UNITED STATES PATENT AND TRADEMARK OFFICE

APPLICATION NO.	FILING DATE	FIRST NAMED INVENTOR	ATTORNEY DOCKET NO.	CONFIRMATION NO.
10/635,363	08/06/2003	Alin Theodor Iacob	100-22100	8885
33402	7590	05/02/2005	EXAMINER	
LAW OFFICES OF MARK C. PICKERING P.O. BOX 300 PETALUMA, CA 94953			TRAN, TAN N	
			ART UNIT	PAPER NUMBER
			2826

Office Action Summary

DETAILED ACTION

Fig. 13

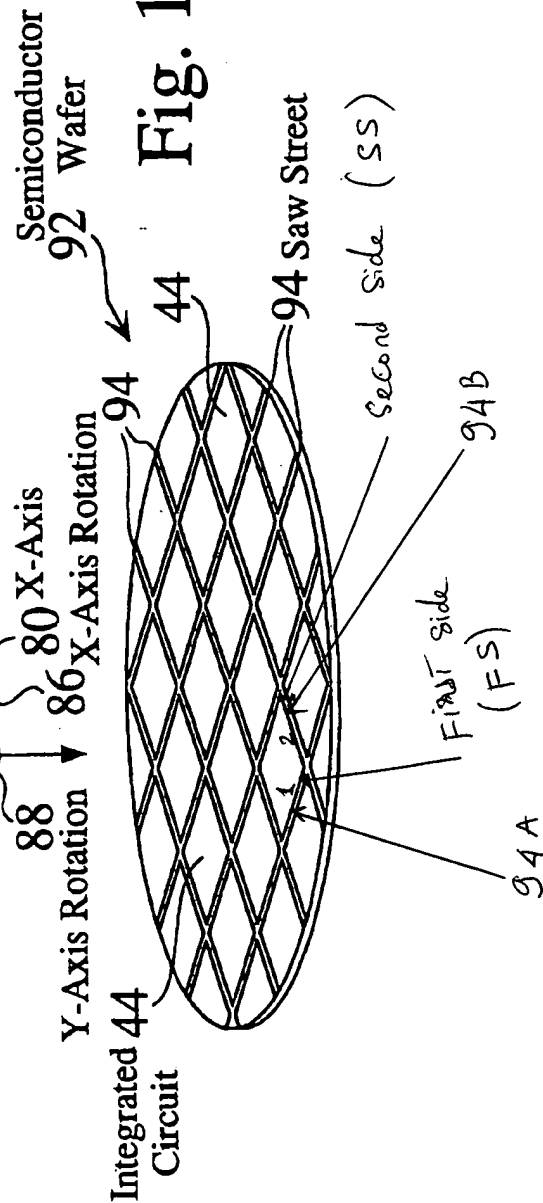
With regard to claims 1,2, Mok et al. discloses a semiconductor wafer 92 comprising: a plurality of semiconductor circuit 44 formed on the semiconductor wafer 92, each semiconductor circuit 44 having a pair of first sides (FS) that are parallel to each other, and a pair of second sides (SS) that are parallel to each other and perpendicular to the pair of first sides (FS); a plurality of first saw streets 94A that run parallel to the first sides (FS) between a number of the semiconductor circuit 44, each first saw street extending in a straight line from a point on an edge of the wafer 92 to another point on an edge of the wafer 92; a plurality of second saw streets 94B that run parallel to the second sides (SS) between a number of the semiconductor circuit 44, each second saw street 94B extending in a straight line from a point on an edge of the wafer 92 to another point on an edge of the wafer 92. (Note attachment #1, fig. 13 of Mok et al.).
